## SERVICE BULLETIN

### REVISION 1 to Service Bulletin SB-T-04-1400C-0001

#### RDR-1400C WEATHER RADAR SYSTEM

IN-2025B Radar Indicator  
P/N 4001670-2511 thru -2520  
Unit Mod 11

Figure 1. Rear Panel CCA

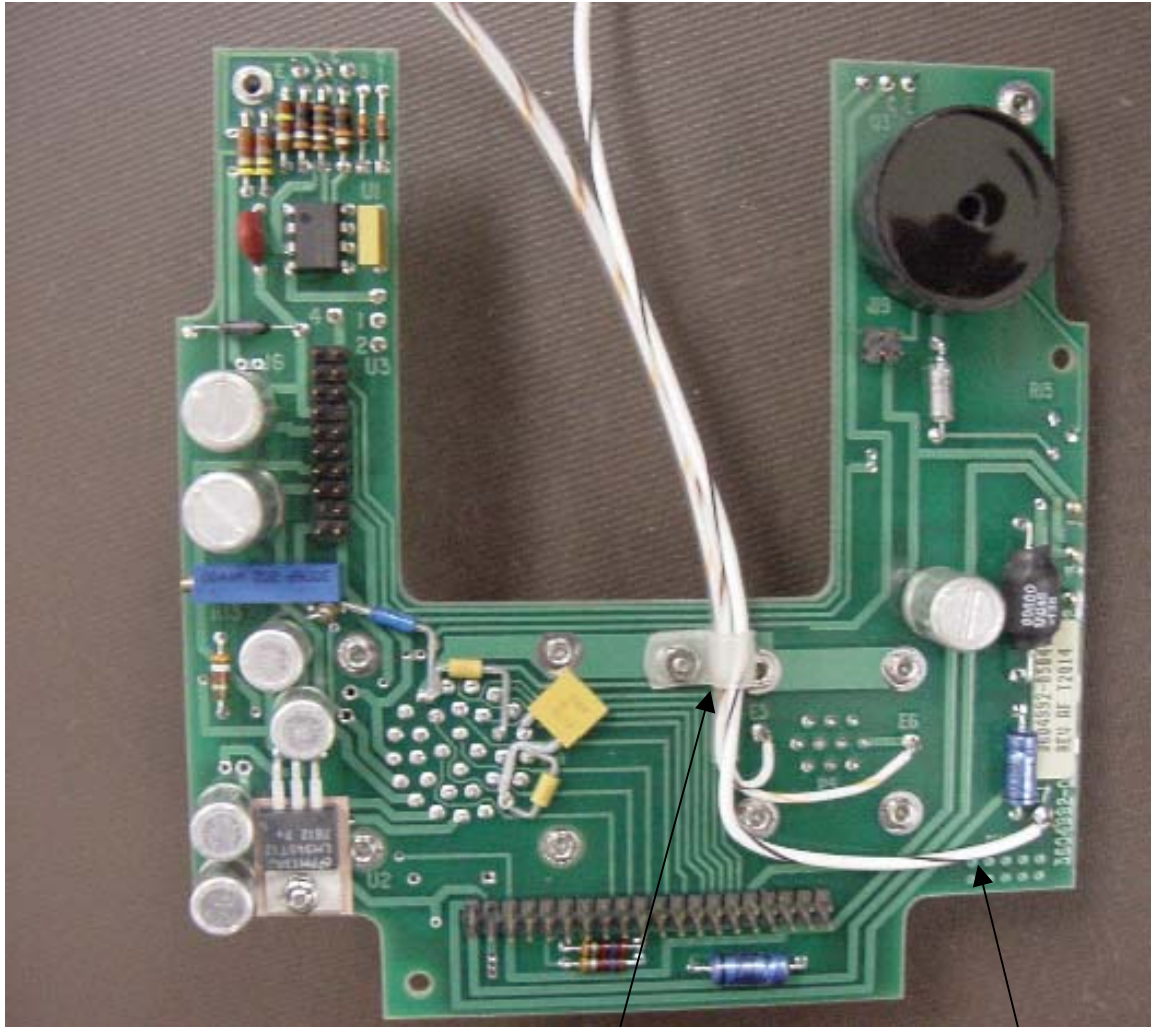
- 1) Disassemble the IN-2025B according to the referenced maintenance manual procedures, to remove the Rear Panel Assembly.
- 2) Remove the Rear Connector CCA p/n 3604992-0504.
- 3) Refer to Figure 1. Remove White/Black wire from Rear Connector CCA and attach Solder lug p/n 32002-002D to the wire.
- 4) Remove clamp from Rear Connector CCA. Remove only the White/Black wire from clamp.
- 5) Replace clamp with new clamp p/n 33033-0003 that holds the other two wires.
- 6) Remove and replace existing Rear Connector CCA rev label with new label.
- 7) Refer to Figures 2 and 3. Attach White/Black wire to HVPS screw using existing screw.

2. Remove and Replace Clamp

1. Remove Wht/Blk Wire
